AMERICAN GENERAL SINGLE ENGINE AIRCRAFT SERVICE KIT NO. 151

Throttle cable support bracket replacement.

FIGURE 1

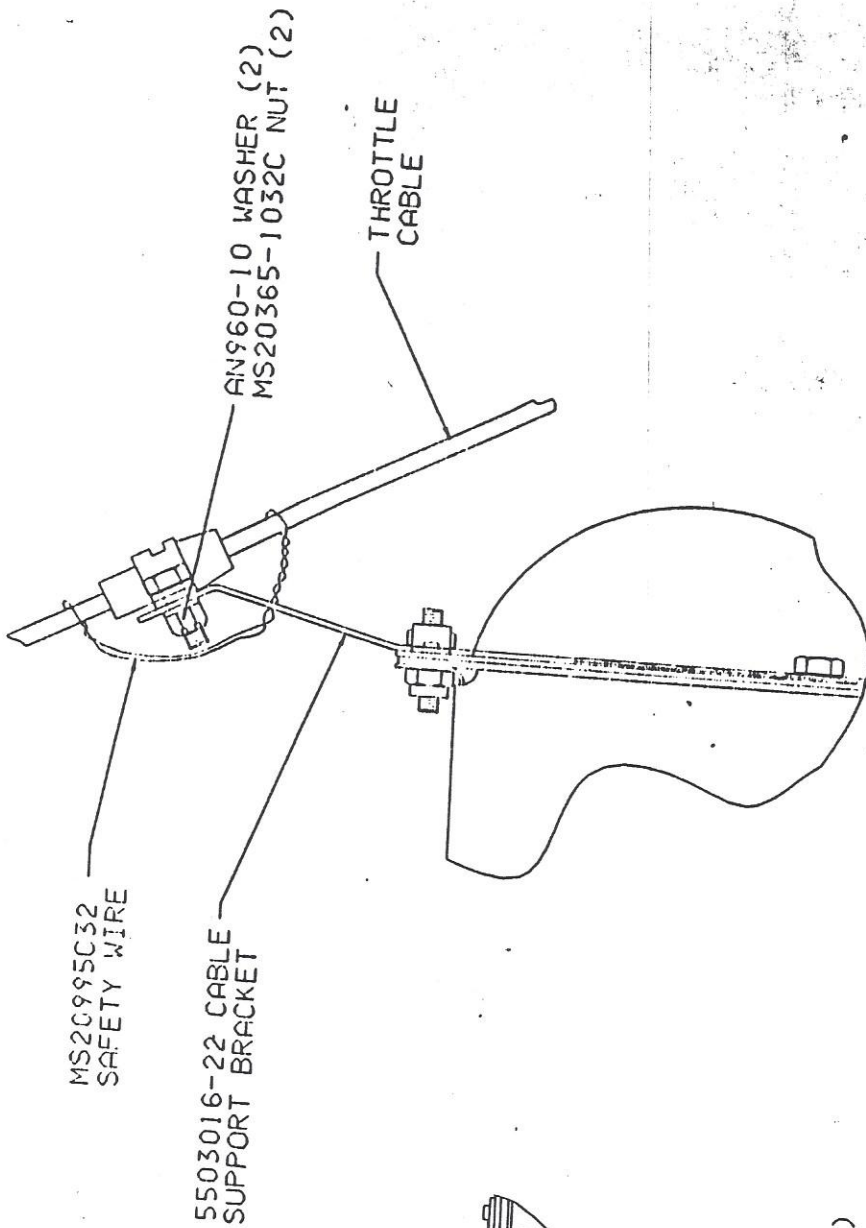
The throttle cable support bracket assembly located on the carburetor air box has been found to wear excessively within a short period of time. This wear could cause the cable to come loose from the bracket and possibly result in loss of throttle control.

- B-1 Remove the carburetor heat cable from the carburetor heat box and retain the hardware (see Figure 1).
  - B-2 Remove the throttle cable from the throttle cable bracket assembly (see Figure 1).

- B-3 Loosen the hose clamps that attach the fresh air and the carburetor heat hoses to the carburetor heat box and remove the hoses. Remove the eight bolts that attach the carburetor heat box to the cover plate and remove the box from the airplane (see Figure 1).

- B-4 Remove the four bolts that attach the carburetor heat box cover plate to the carburetor and remove the cover plate and gasket from the airplane (see Figure 1).

FIGURE 2

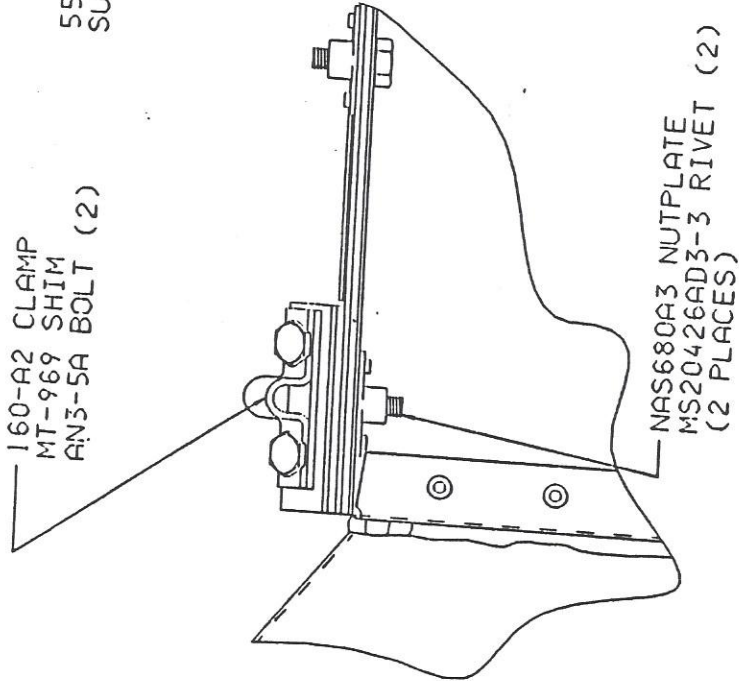
- B-5 Remove the two nutplates located on the left hand side of the carburetor heat box cover plate using a #40 drill bit to remove the rivets (see Figure 2).

- B-6 Attach the NAS680A3 nutplates and MS20426AD3-3 rivets provided to the carburetor air box as shown in Figure 2.
  - B-7 Install the 5503009-2 Gasket and the carburetor box cover plate on the aircraft using the same bolts that attached it before.

- B-8 Install the modified carburetor heat box and the 5503016-22 cable support bracket using the original attach bolts as shown in Figure 2.
  - B-9 Reattach the carburetor heat and fresh air hoses and tighten the hose clamps.

- B-10 Reattach the carburetor heat control cable to the carburetor air box.
- B-11 Attach the throttle cable to the cable support bracket using the MT-969 shim, the 160-A2 clamp, two AN3-5A bolts, two AN960-10 washers, and two MS20365-1032C nuts as shown in Figure 2.
- B-12 Run MS20995C32 safety wire around the throttle cable and through the bracket as shown in Figure 2.
- C. Return aircraft to flight status.
- D. Record compliance in the aircraft logbook.
- E. Please fill in the attached compliance card and return it to:
